UNITED STATES PATENT AND TRADEMARK OFFICE

APPLICATION NO.	FILING DATE	FIRST NAMED INVENTOR	ATTORNEY DOCKET NO.	CONFIRMATION NO.
10/621,317	07/18/2003	Ashvin D. Desai	87344.1524	2539

Office Action Summary	Application No. 10/621,317	Applicant(s) DESAI ET AL.	
	Examiner Matthew O. Savage	Art Unit 1724

U.S. Appl. No. 10/621,317
Amdt. Dated Feb. 21, 2006
Reply to Office Action of Sep. 21, 2005
ANNOTATED SHEET SHOWING CHANGES

FIG. 4

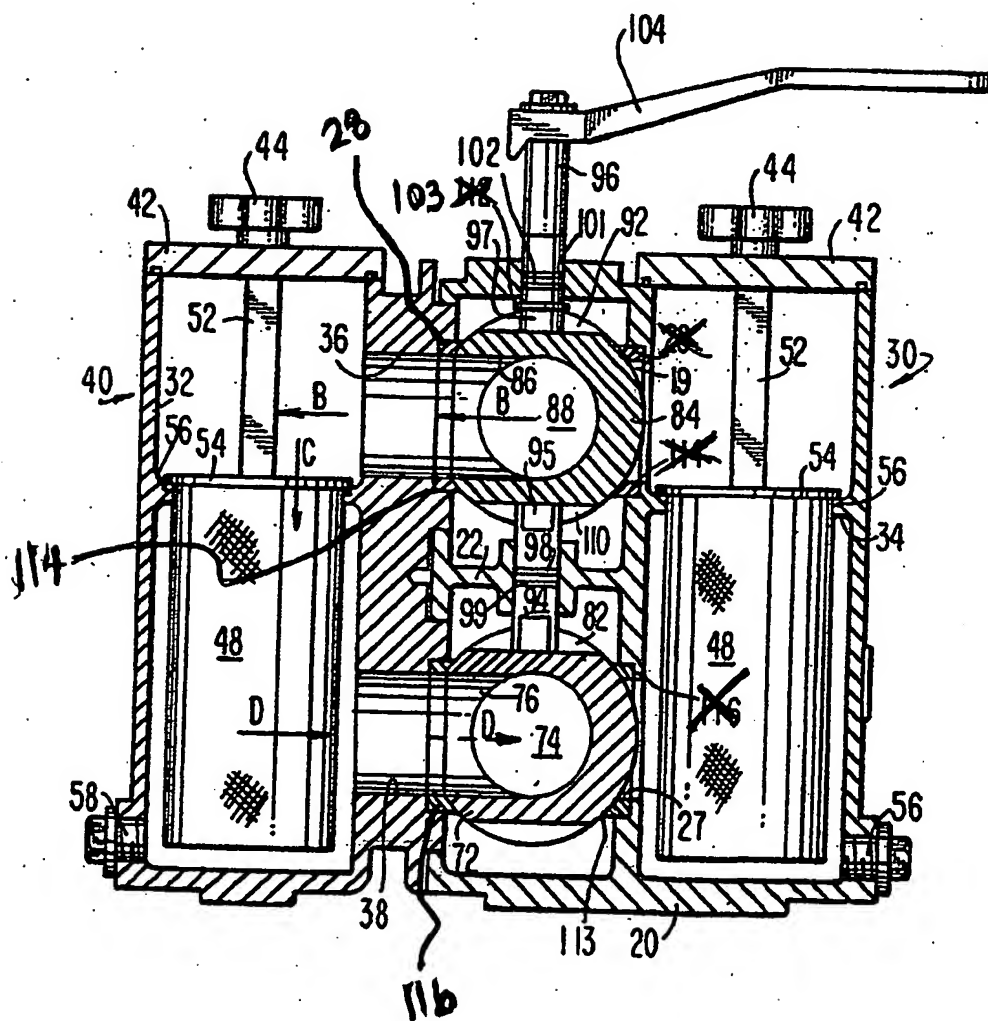
Applicant argues that the recitation of a first strainer chamber for straining and a second strainer chamber for straining provides sufficient structure for supporting the preamble, however, the associated rejection under 35 U.S.C. 112, second paragraph is maintained since it remains unclear as to how a straining function can be accomplished since no strainer structure has been recited in the claim. It is suggested that the body of all of the claims be amended to positively recite strainers (e.g., corresponding to the

structures 48 shown in FIG. 4) disposed in the respective strainer chambers to obviate the rejection.

Okay to enter.
mg
